SERVICE BULLETIN

TR-2400

#807

SUBJECT: TR-2400 OPTIONAL CHARGE INPUT PROTECTION

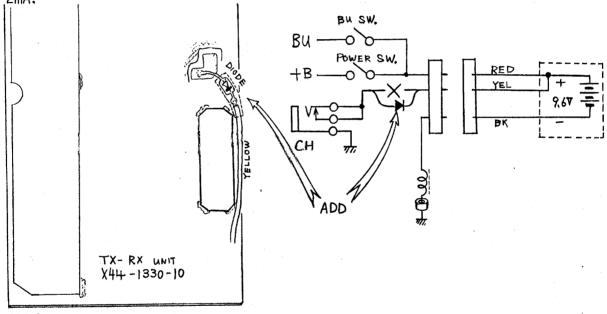
Some users may request addition of a series diode to the Charge Jack to prevent inadvertent shorting of the battery pack if a voltmeter probe, headphone jack, or other conductor accidentally shorts across the external Charge Jack. This can be used only for the standard wall charger. The optional fast chargers require battery voltage be available at the charge jack as feedback to the charger regulator.

Add a Si diode in series with the battery charge line, at the Charge Jack. Observe battery polarity, as shown. Charging current will drop approximately 2mA.

- 1. Si diode must be rated at least 200mA.
- 2. Install carefully-don't short the YELLOW B+ lead when reassembling.
